**ENVIRONMENTAL
IMPACT REPORT
FOR THE SPRING
TRAILS SPECIFIC
PLAN**

SCH NO. 2009111086

**CITY OF SAN
BERNARDINO**

**THE PLANNING
CENTER | DC&E**

Trails, Parks, and Open Space Plan

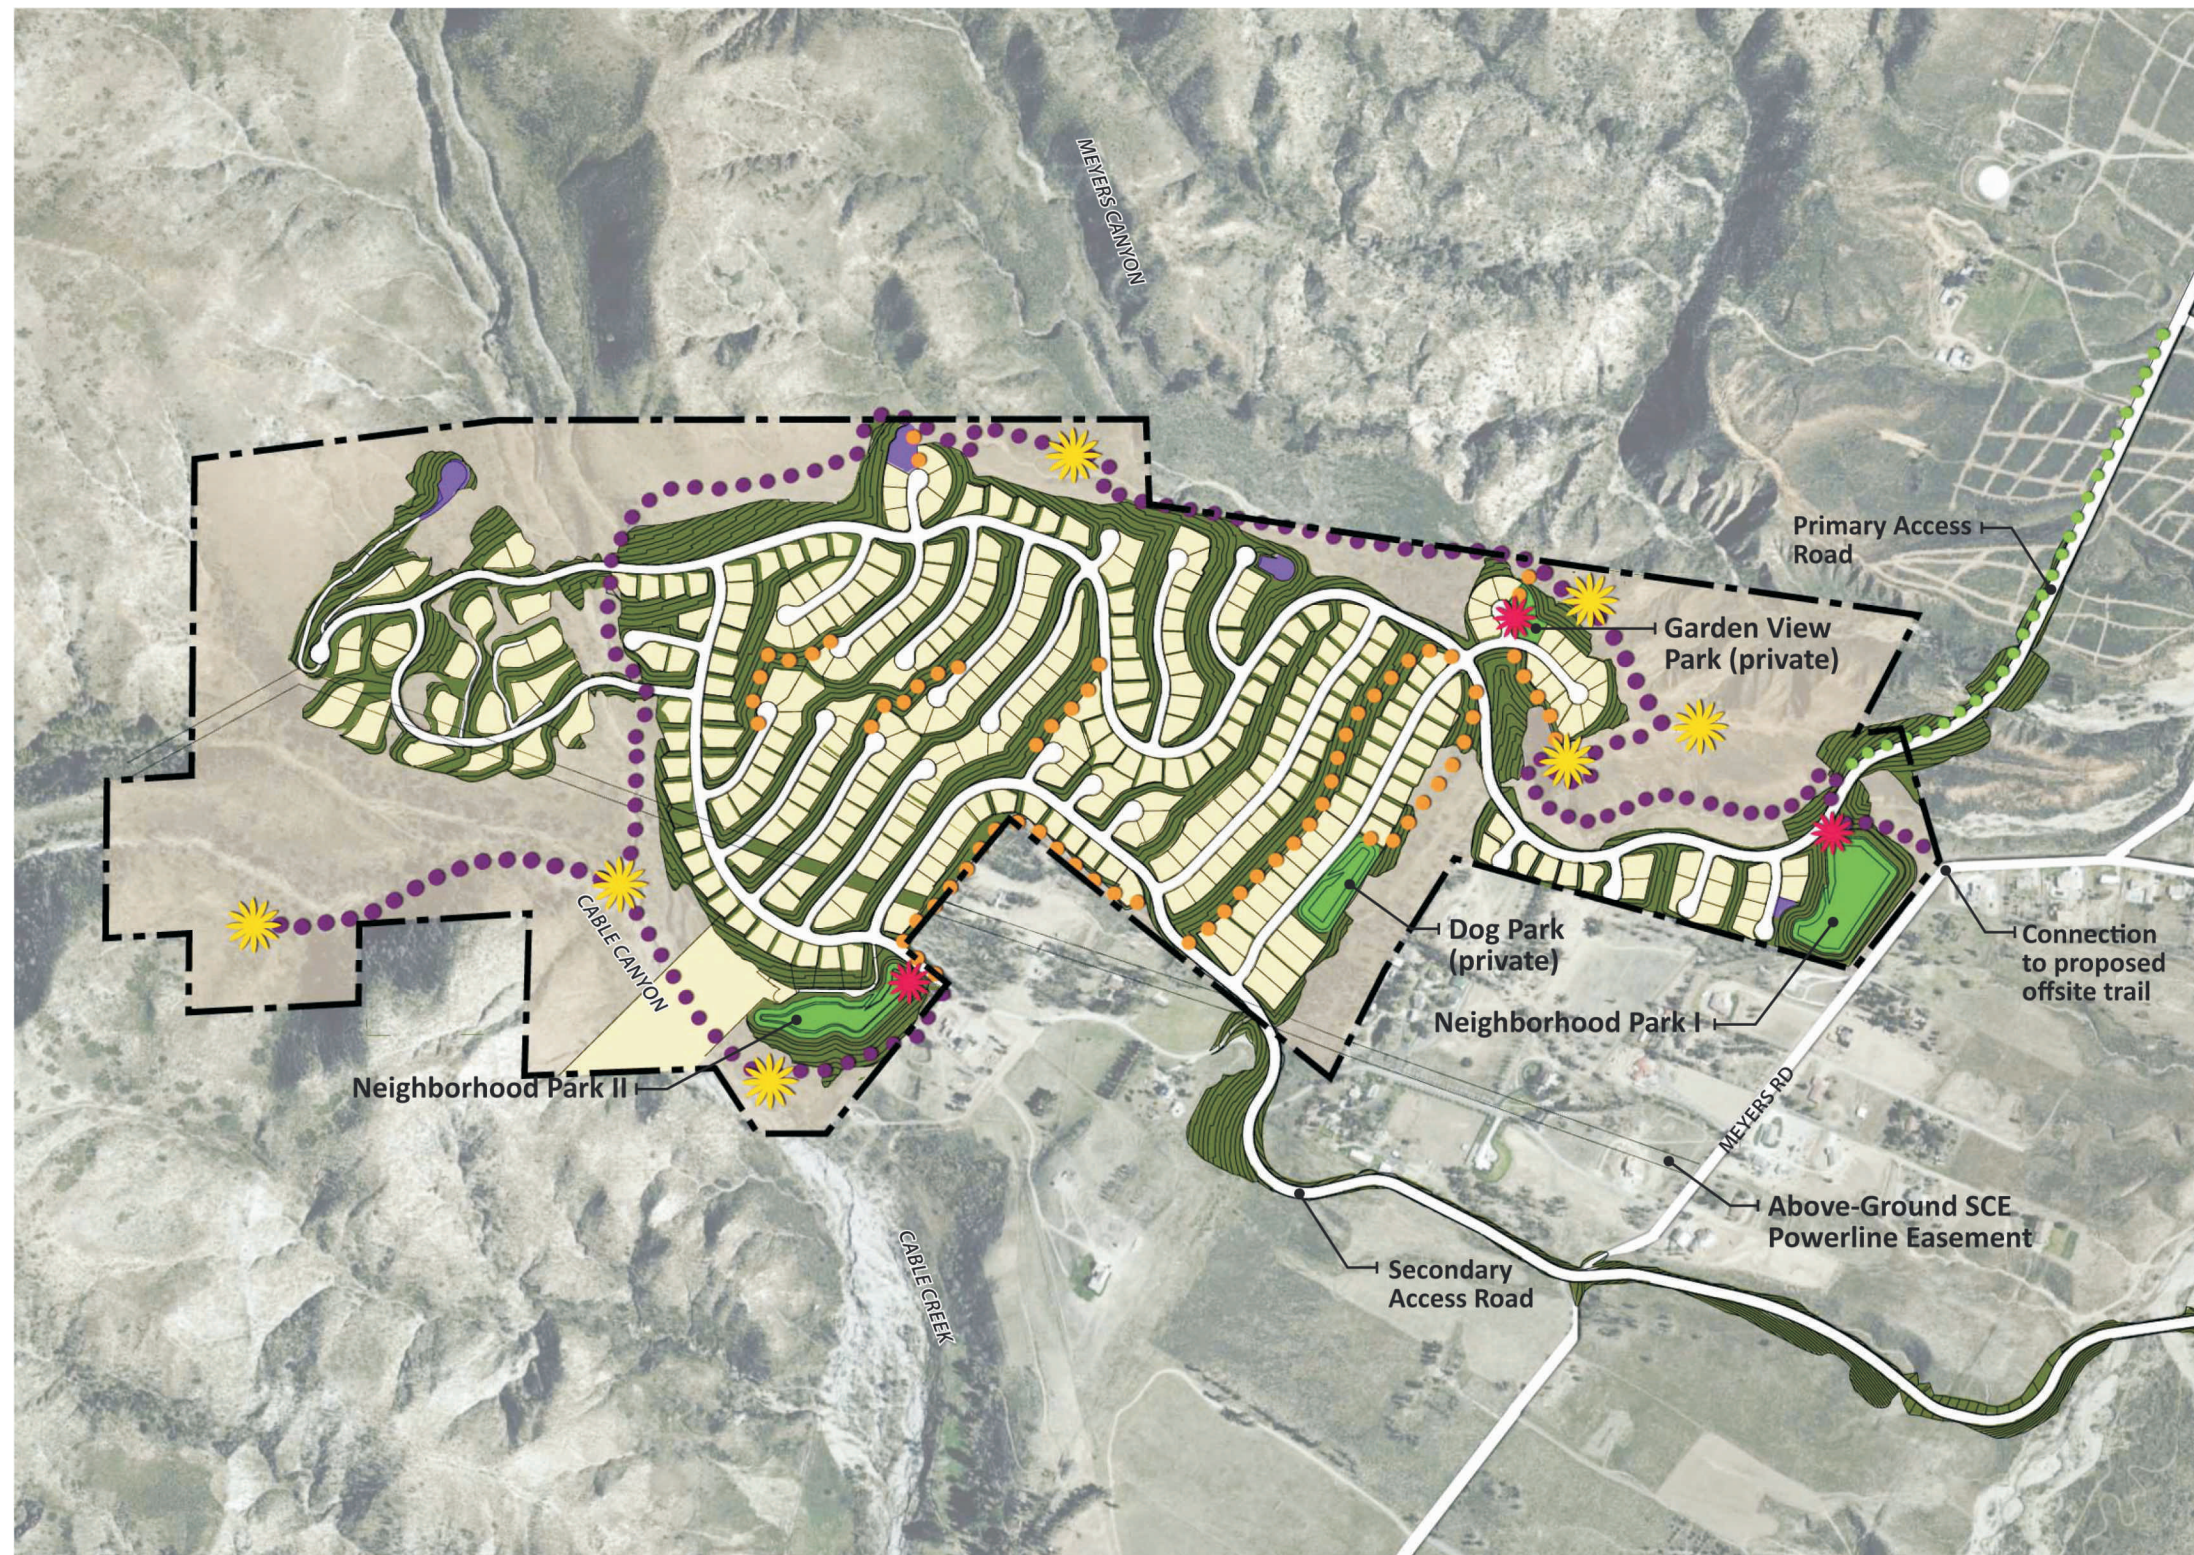
According to Figure 3-8 showing the Trails, Parks and Open Spaces, there will be a 4-foot hiking trail which begins with a trail head directly across the street from our front yard and only travels the perimeter of our properties directing the public to meander the edges of our properties, thus allowing no privacy for our residences. We ask that this trail be removed from the trail system.

Existing Land Use Designations

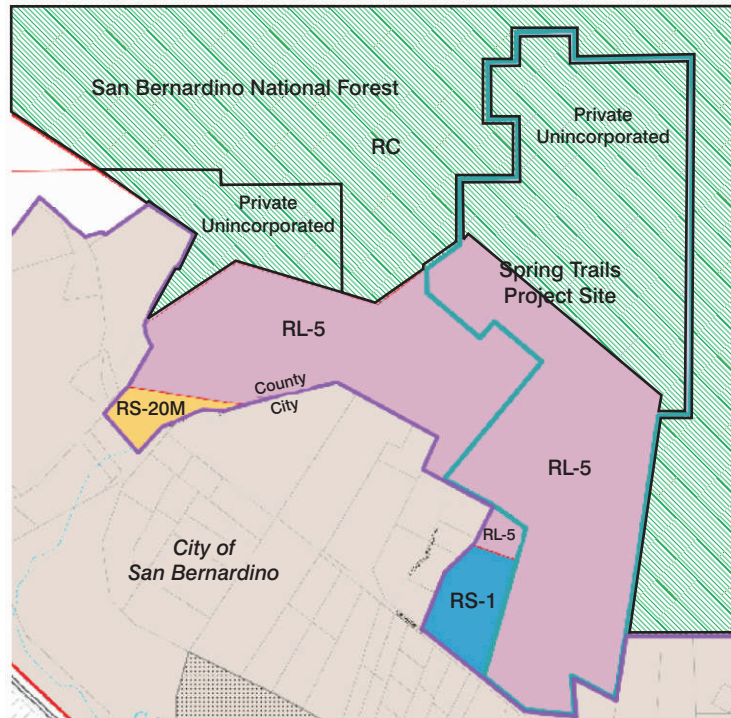
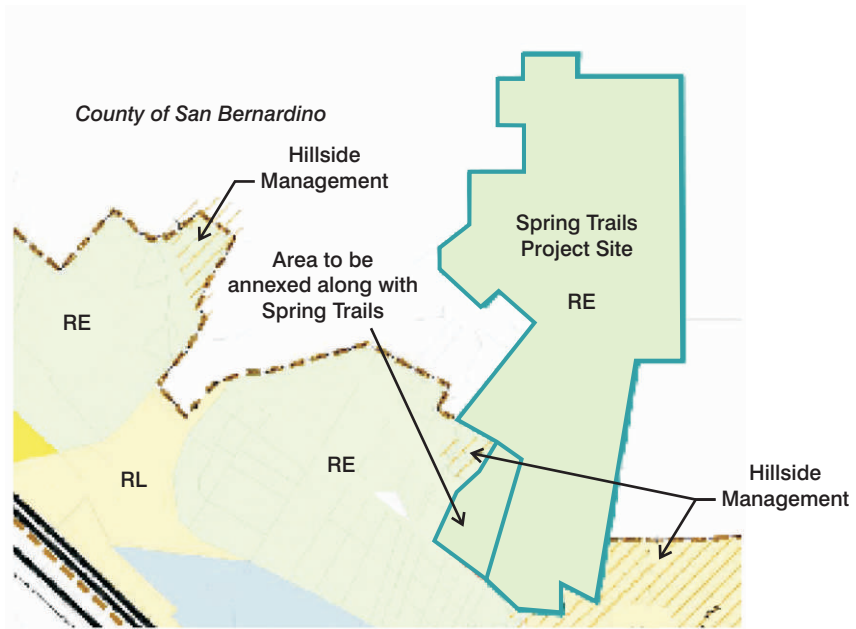
- Section 4.3.12 General Plan and Zoning (City of San Bernardino), page 4-24, indicates that the project site is zoned Residential Estate (RE) in the City. However, there is no additional statement that the additional 26.4 acres is also zoned as RE especially since the City's land use map (shown on Figure 4.6) shows the area with a different color than what is shown as the area with the RE designation.

It is also LAFCO's suggestion that the area labeled as "Private Unincorporated" be removed from the County's land use map (shown on Figure 4.6) in order to clearly show what the land uses are in the County. By having a different color and/or label for "Private Unincorporated", it will be construed by a reader that Private Unincorporated is a specific land use designation under the County's jurisdiction.

- A8-1 As stated in the comment, the 26.4-acre area to be annexed with the project site is also pre-zoned Residential Estate (RE) by the City. Chapter 4 of the Draft EIR, *Environmental Setting*, has been revised to clarify that both the project site and the 26.4-acre area are pre-zoned with the same land use. Figure 4-6 has also been revised. The revised text is found in Section 3.2 of the FEIR, *Revisions in Response to Written Comments*, and the revised figure is found in Section 3.3, *Revised and New Figures*.

- A8-5 Figure 4-6 of the Draft EIR has been revised to more clearly indicate the County's land use designations. The northern portion of the project site is now the same color as the rest of the RC-designated areas. The revised figure is in Section 3.3 of this FEIR.

Plant Communities Map

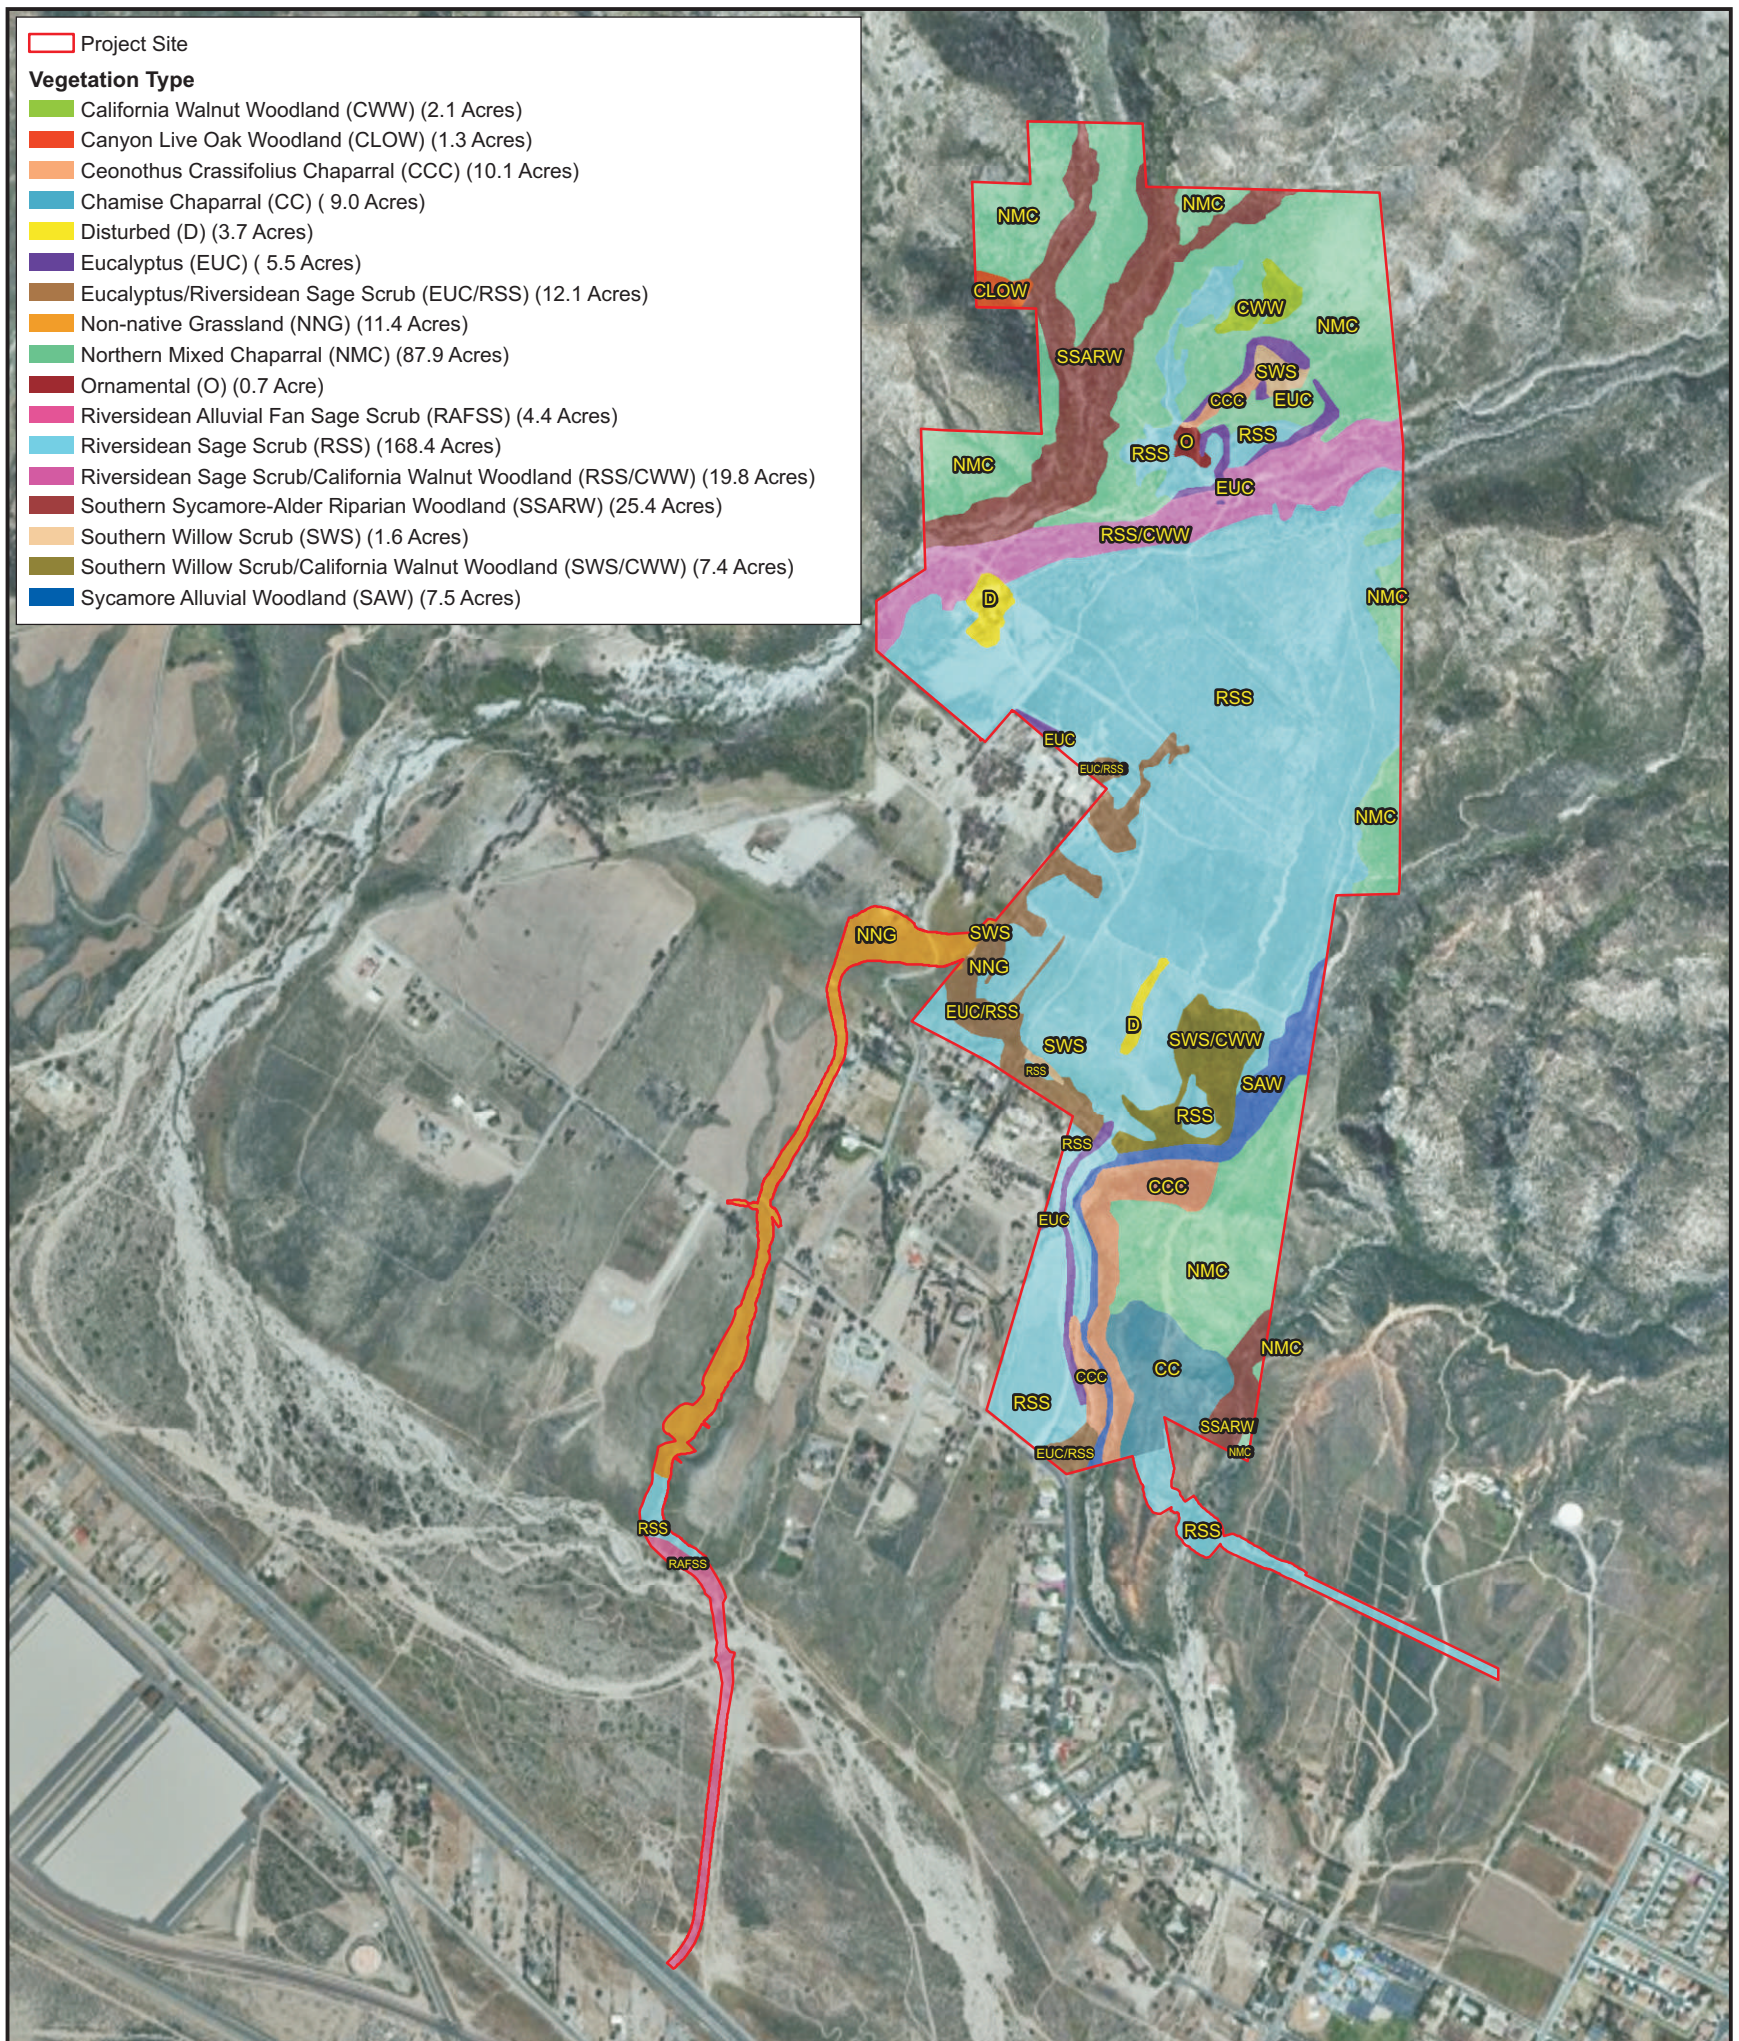
The proposed Spring Trails project would result in the overall direct loss of the following sensitive and rare plant communities: more acres of Riversidian Sage Scrub (RSS) than are described as occurring on site! Table 5.3-5 indicates that 168.4 acres of RSS will be impacted by the project development (DEIR at 5.3-49, however, Figure 5.3-1 (DEIR at 5.3-5) indicates that only 167.9 acres occurs on site. The same type of inaccuracy between the Figure 5.3-1 and Table 5.3-5 is found for four other on-site rare plant communities including RSS/CWW, RAFSS, SSARW, and SAW. These discrepancies in acreage for a rare plant communities are important based on the need for substantial mitigation (see below). It strongly suggests potential inaccuracies in other “estimates” of vegetation types on the proposed project site. CEQA requires clear and consistent identification and analysis of impacts.

- A4-4 The acreage calculations in the text and Table 5.3-5 are correct. Figure 5.3-1 has been revised to be consistent with the rest of the document. The revised Figure 5.3-1 is provided in Section 3.4 Revised *and New Figures*.

Existing Average Daily Traffic Volumes

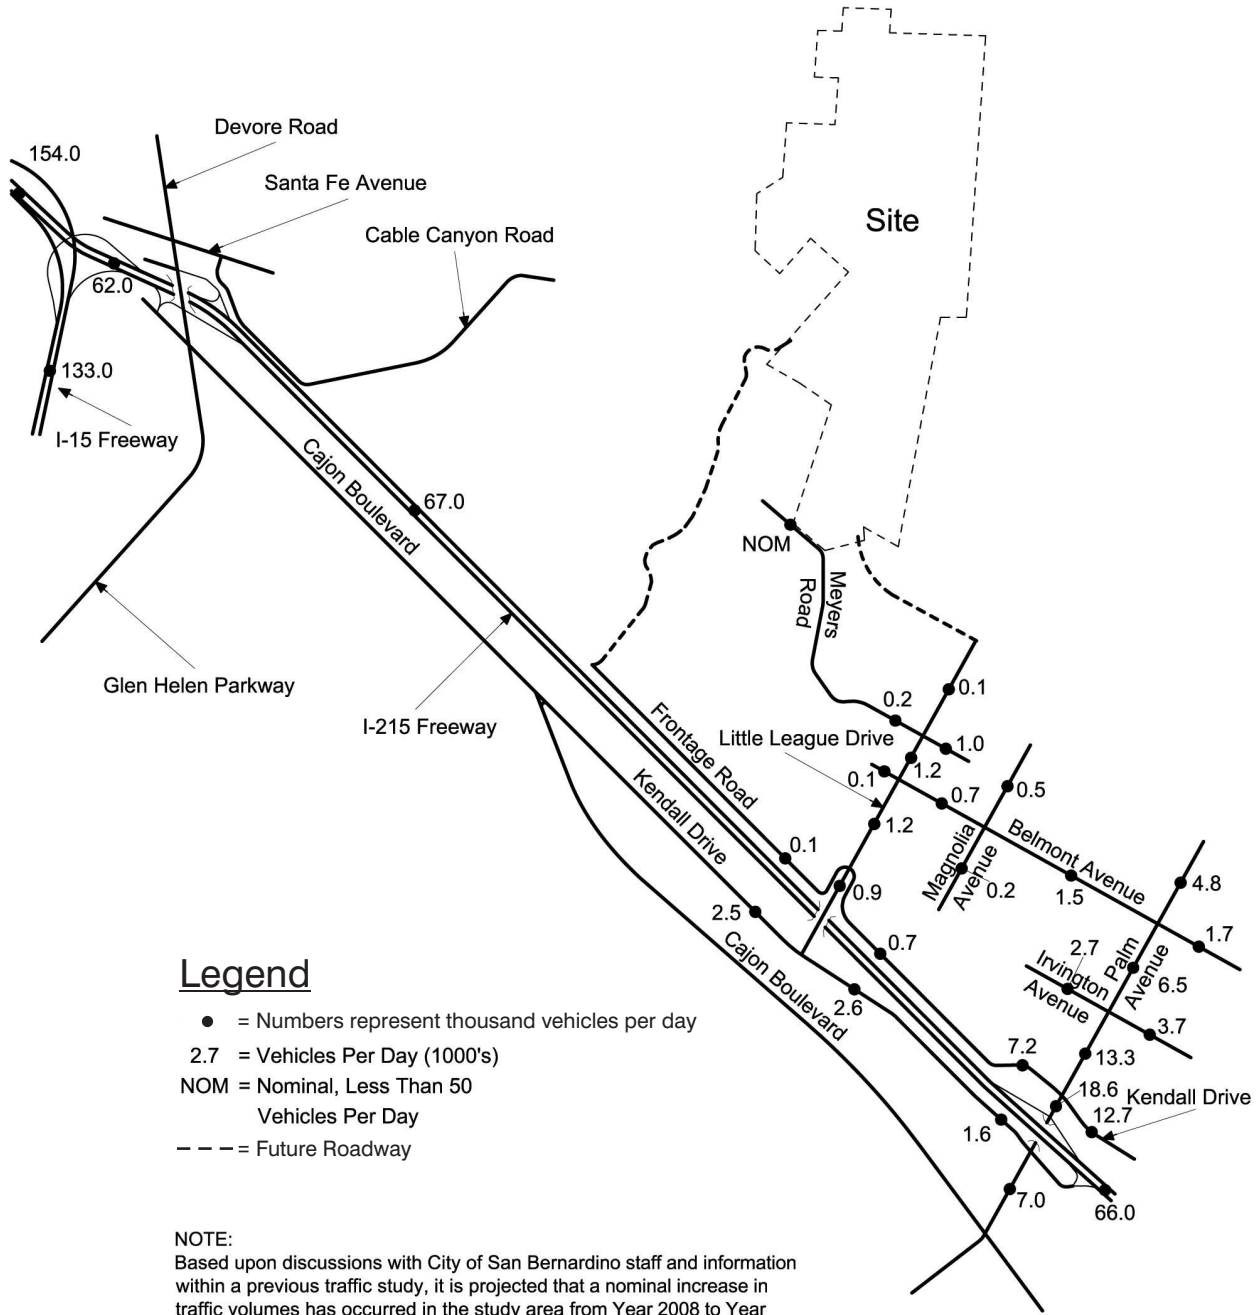
1. Table 1, Figures 4, 5, and 6; there are two different years of traffic data collected for the proposed study. Label and verify the existing year (i.e. 2008 or 2009)		A2-1

A2-1 Table 1 and Figures 4, 5, and 6 of the traffic study have been revised to indicate the existing year as a footnote or in the legend (see Appendix A of this FEIR). In the Draft EIR, Table 5.14-2 and Figure 5.14-5 have been revised to reflect the changes. The revised table and figure are found in Section 3, *Revisions to the Draft EIR*, of this FEIR.
